From: Bruce Woodis <bwoodis@kwpinc.com>
Sent: Thursday, February 18, 2021 3:29 PM
To: Margaret Washburn
Cc: 'Kristine'; 'Nicholas Lehto'
Subject: Erickson - Wolf Den Road
Attachments: erickson.pdf

Wolf Den Rd Map 18 Lot 19B-1

SUBJECT: FILE #21000296 -- WOLF DEN ROAD #DL 19B-1, MAP #18, LOT #19B-1, BROOKLYN,

Re: Proposed lot # 19B-1 - 3.95 ac - Wolf Den Rd, Brooklyn, CT. Erickson Property

Wolf Den Road - Erickson/KWP

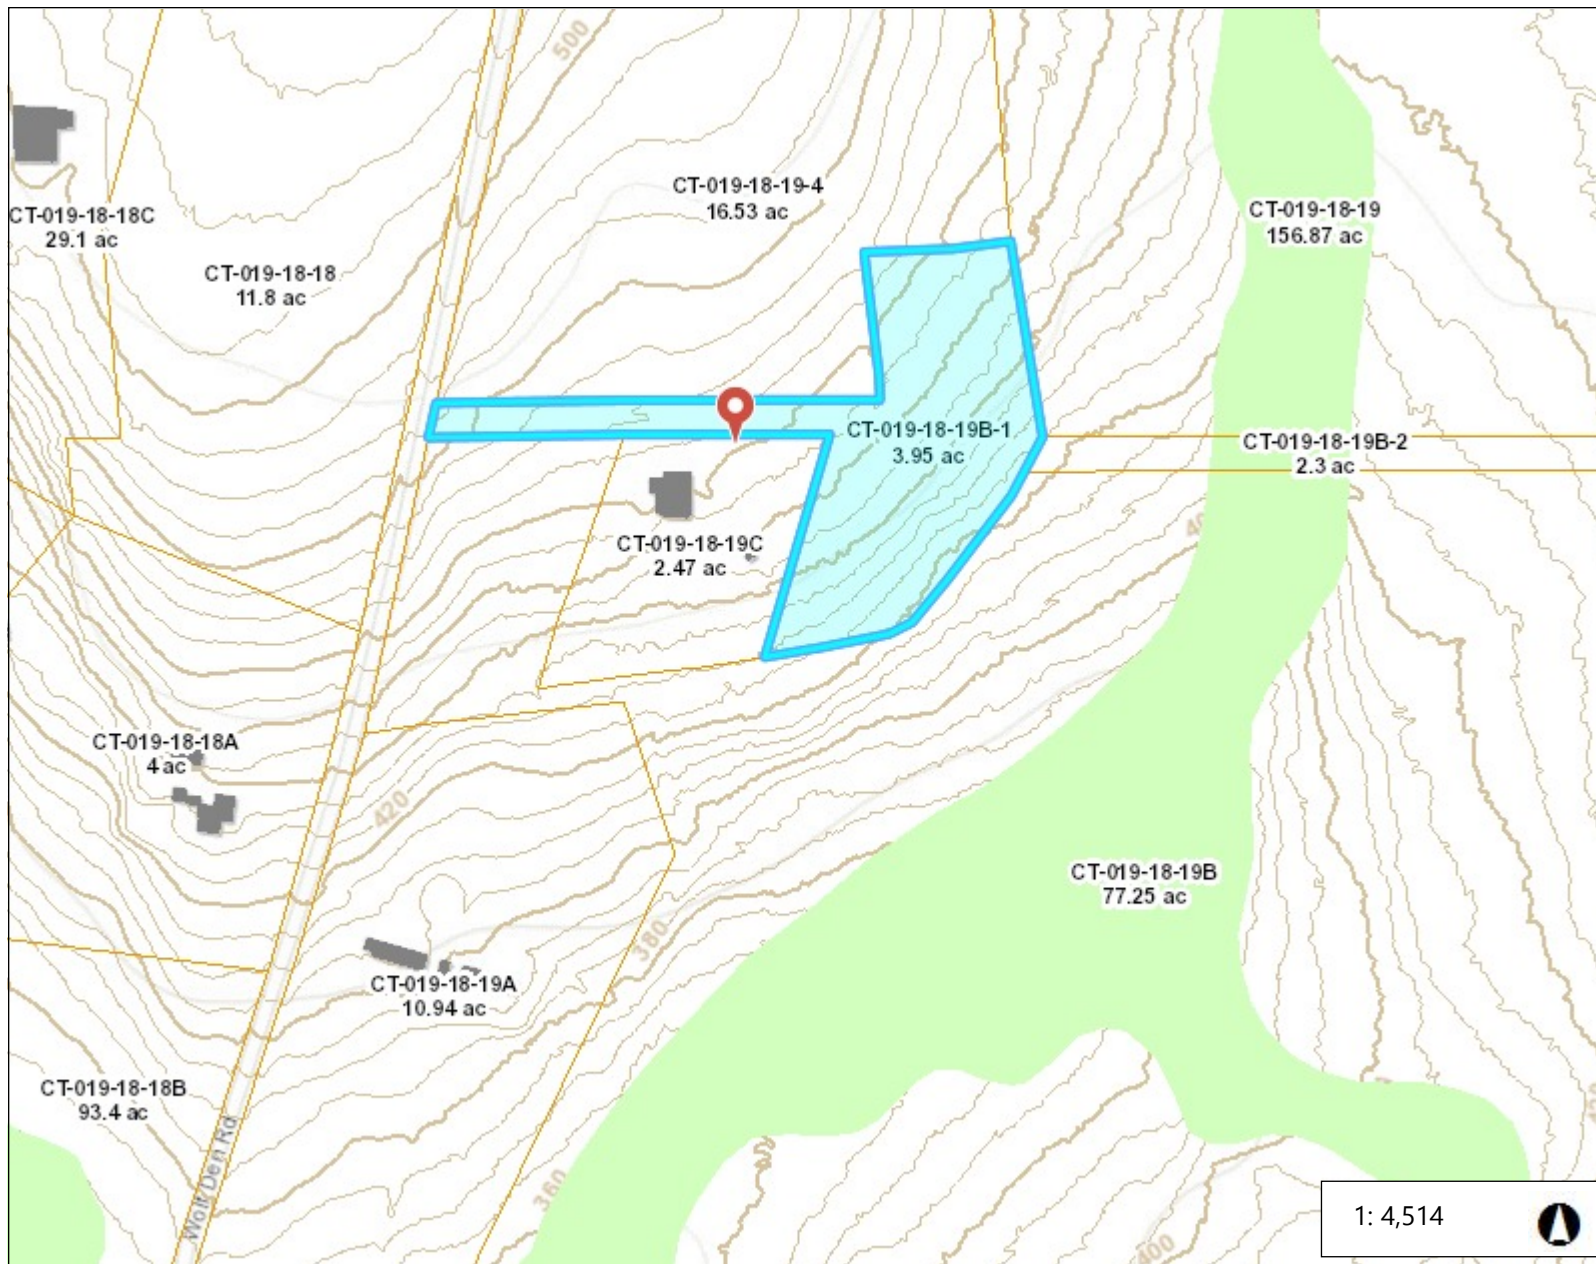
I met Bruce Woodis, inspected and took photos.
The lot is bisected by a stone wall that runs east/west.
The abutting property to the east of the upper (northern) half
has not been checked for wetlands according to Bruce Woodis.
According to Google Earth maps, the closest point
of wetlands to the upper half of the lot is about
250 feet. (northern)

The same Google Earth map indicates that the closest point
of wetlands to the lower (southern) half of the lot is also
about 250 feet. However, when the soil scientist investigated,
wetlands were found to be present on the subject property.
For this reason, I recommend that a soil scientist should
verify whether there are jurisdictional wetlands east of the
upper (northern) half of the lot that would project an upland review area
onto the subject property.

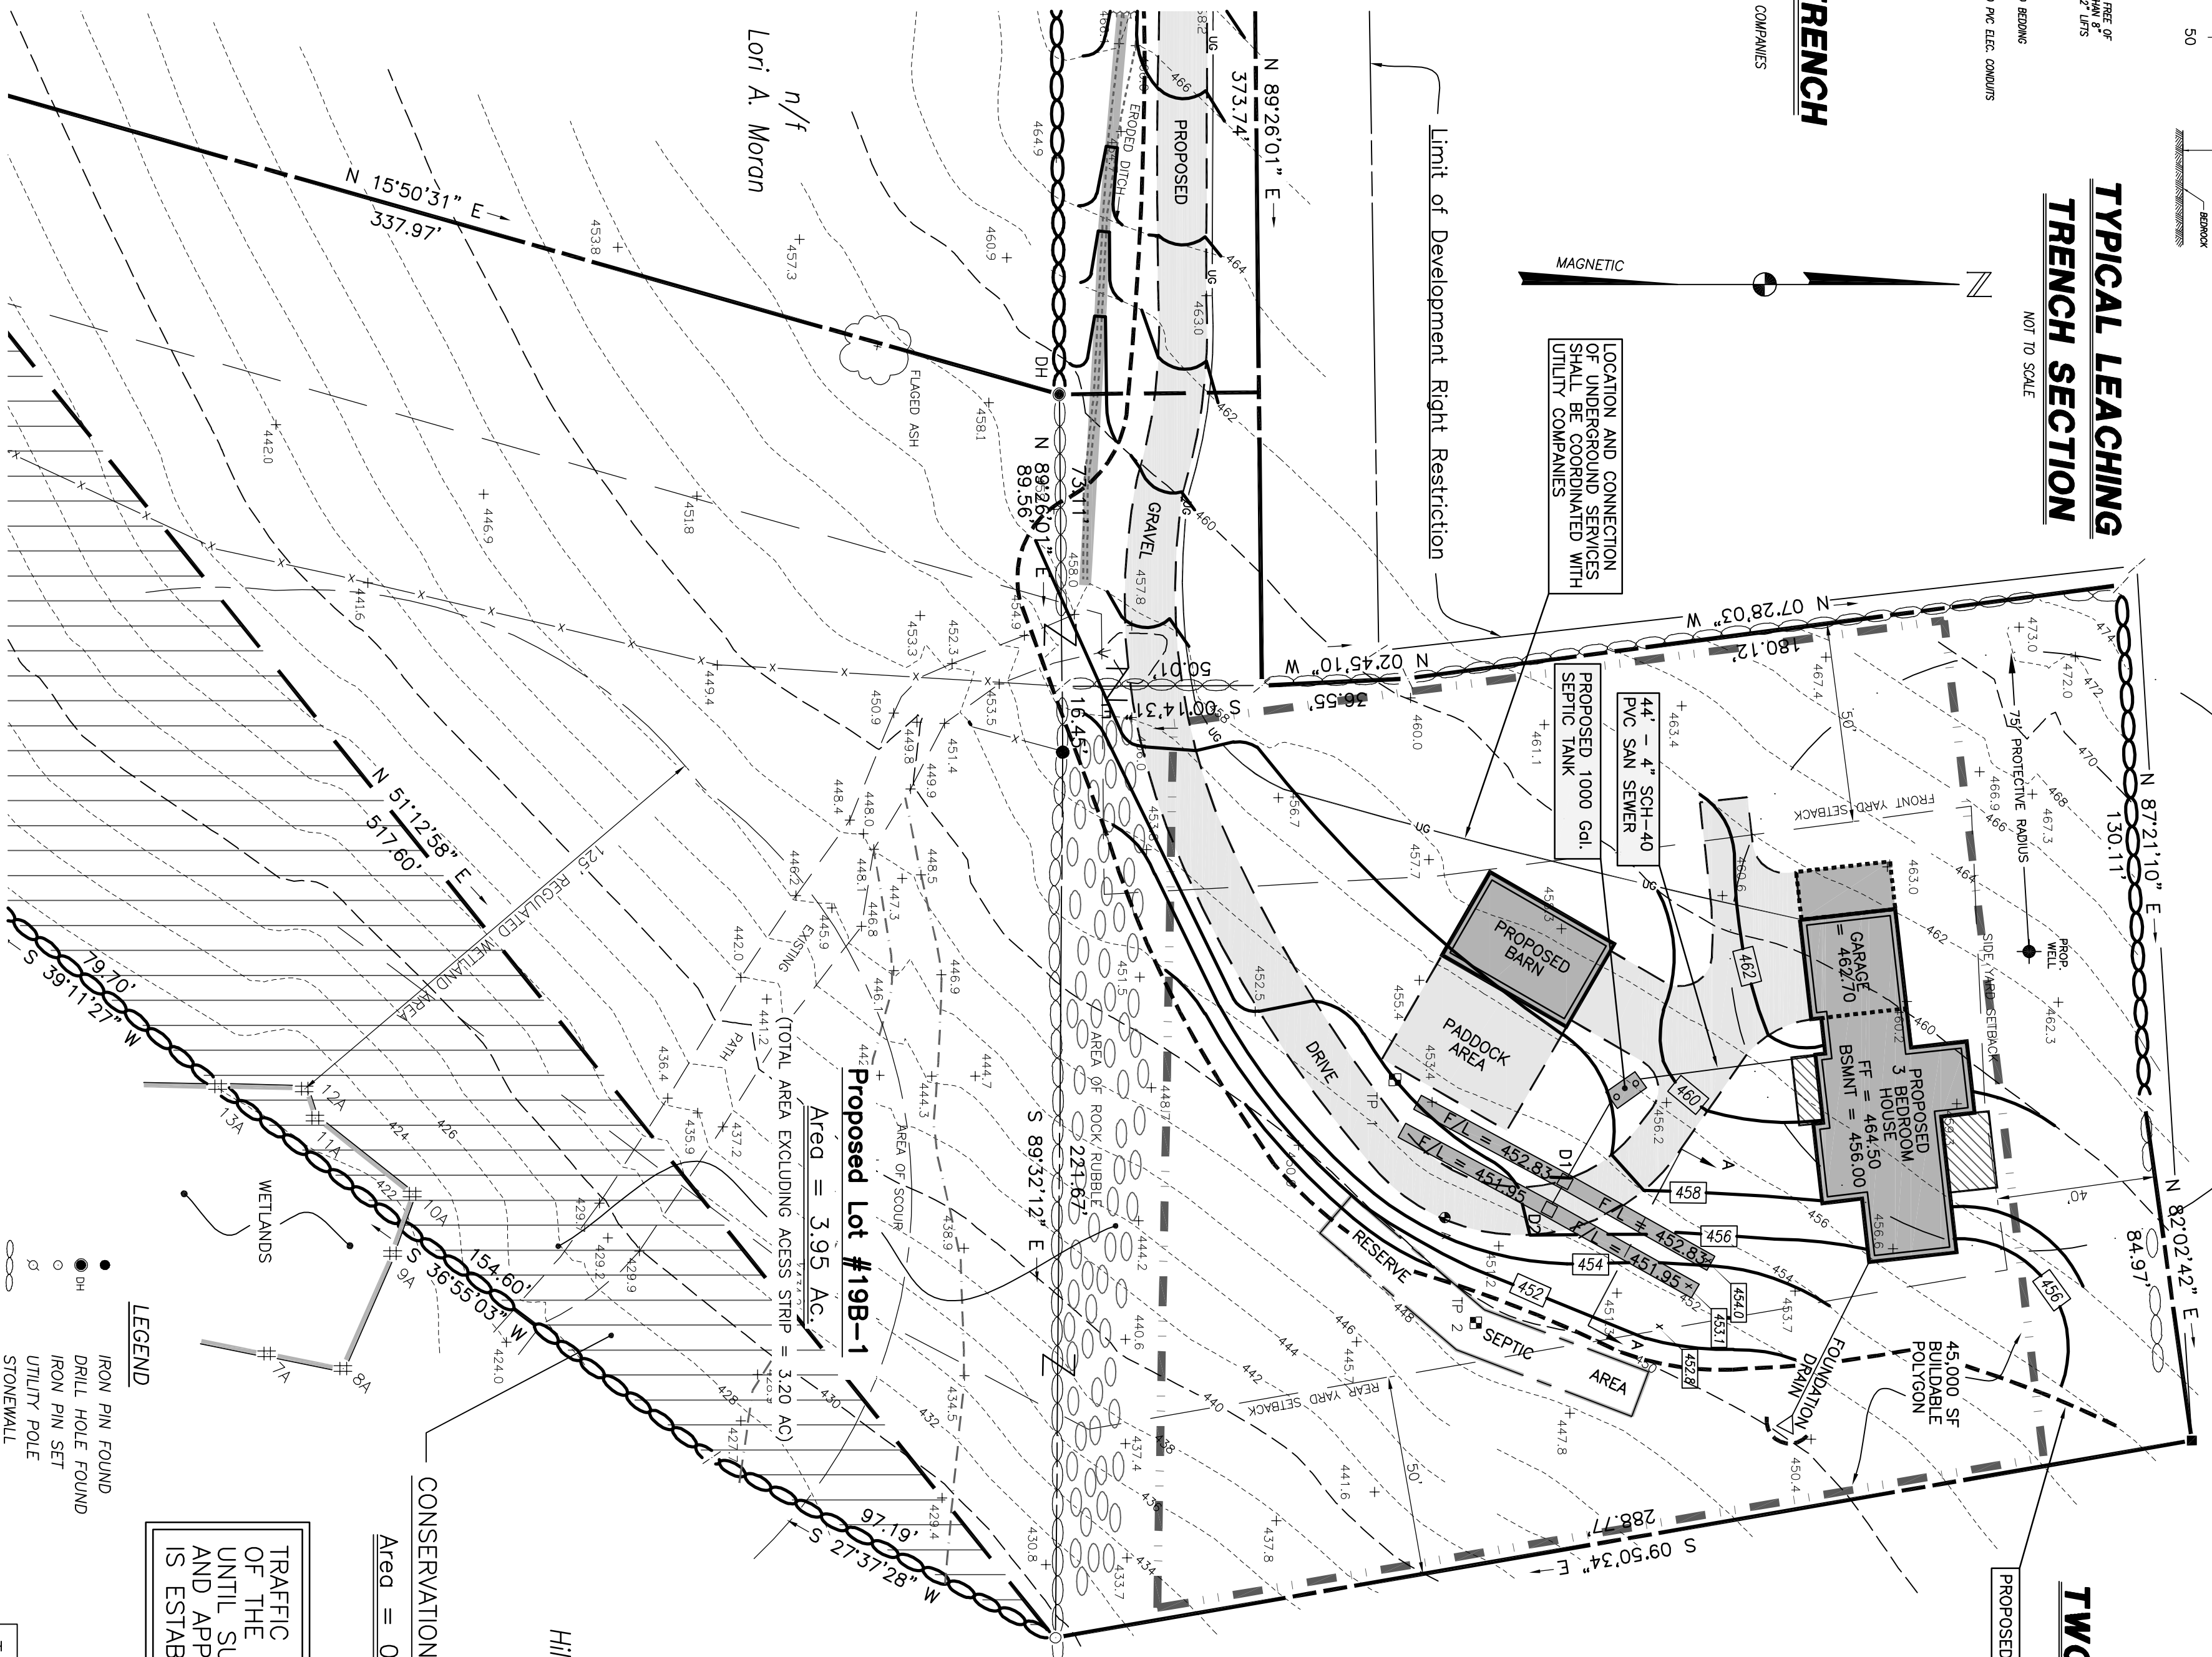
The subject plan (KWP ASSOCIATES, PROJ# 99077, DRAWN 02/01/2021, REVISED 02/24/2021) submitted on 2/25/2021 has been reviewed, as requested. Following completion of this review, it has been determined that the subject plan will meet the requirements of the Technical Standards for a 3 bedroom house based on the following:

1. CT licensed surveyor must stake house, well; benchmark, and septic system, offset stakes to include flow line or bottom of trench elevation.
2. Permanent benchmark to be set within 50 feet horizontally and 12 feet vertically of septic system.

3. A bottom of excavation inspection is required once the topsoil and fill material have been removed.
4. A current sieve analysis of select fill material (within past 30 days) must be submitted to the Northeast District Department of Health (NDDH).

5. Select fill is to be perced once in place.
6. A set of house plans must be submitted prior to an Approval to Construct Permit being issued.
7. An Installer's As-Built drawing (to include ties to the house) is to be submitted following the final inspection and approval of installation by NDDH.

8. Installer to schedule and be present for the final inspection with NDDH staff. Level to be set up for verification of elevations OR an Engineer's As Built will be required.
